UNITED STATES ENVIRONMENTAL PROTECTION AGENCY
REGION IX
75 Hawthorne Street
San Francisco, CA 94105

RE: Duck Valley Emergency Order Work Plan

TO: John Krause, BIA

FROM: Alisa Wong and Cynthia Sans, EPA

Map #2

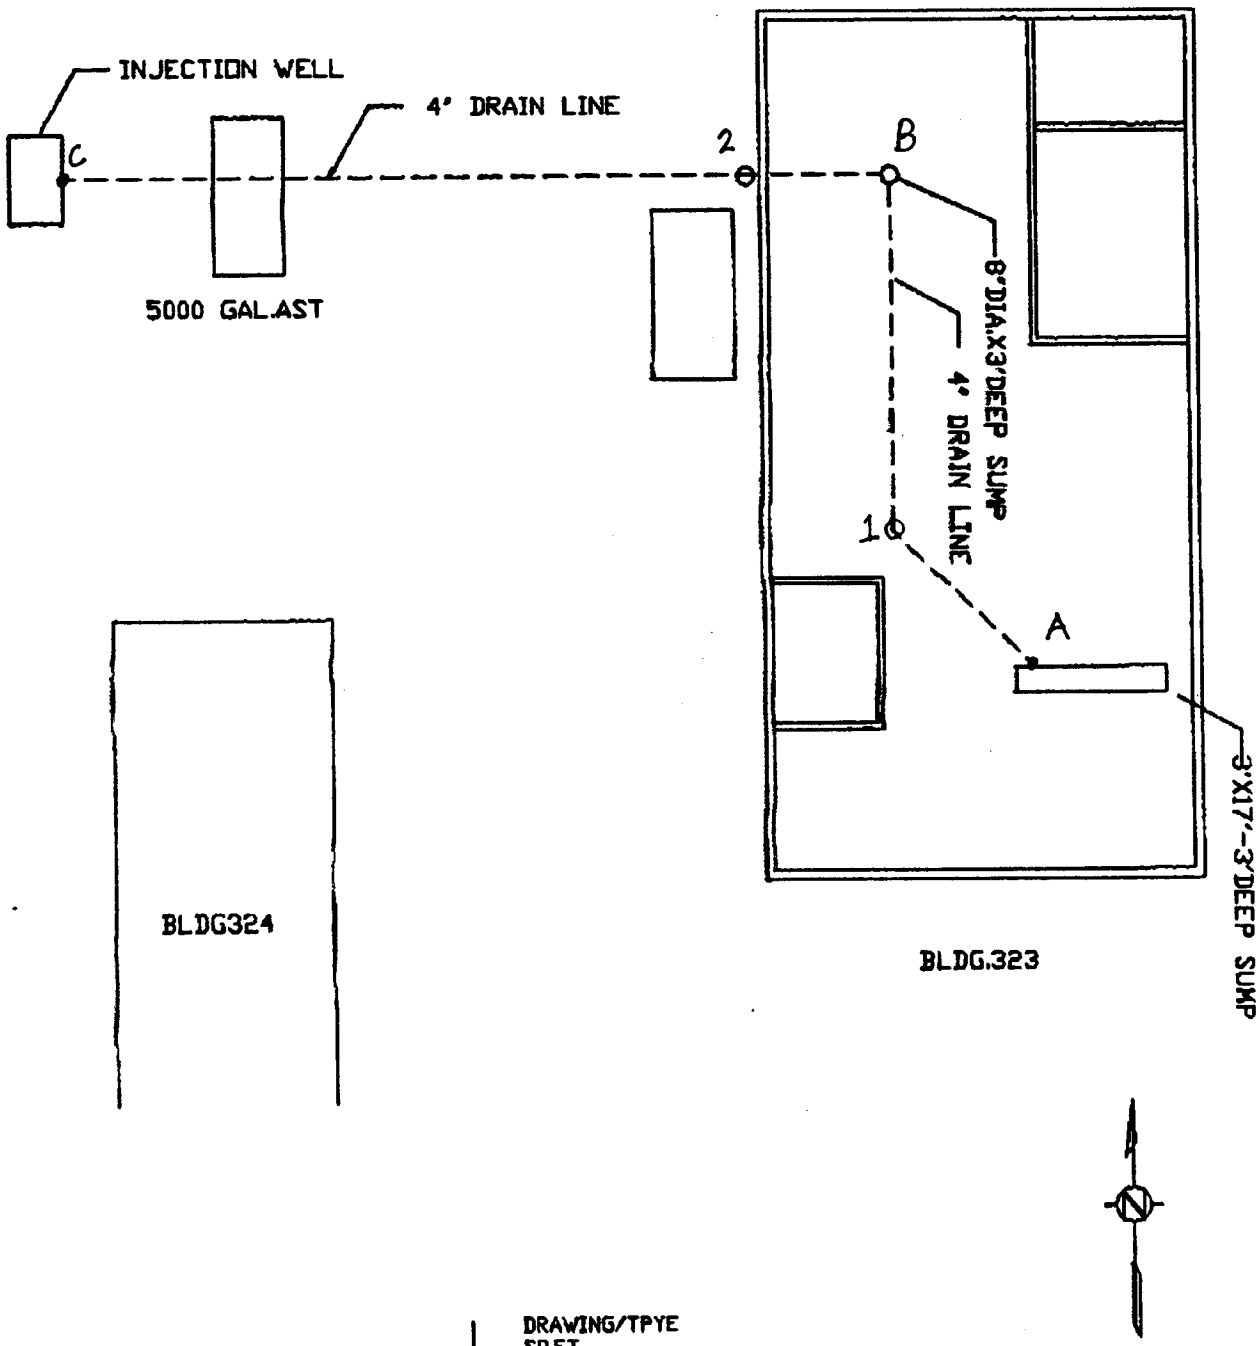
Point C (Refer to part g of BIA Work Plan)--four samples are to be taken in the area around the discharge outlet. See Map #2 for EPA recommended sampling locations;

Points #1 and #2 (refer to part f of BIA Work Plan)--The BIA Work Plan includes four samples along the drain line of the drain system, EPA suggests at Point #1, two samples be taken. One 3' below the elbow of the drain line and the second at the surface of the water table. At Point #2, two samples should be taken. One sample 3" below the end of the vertical pipe and a second sample at the top of the water table.
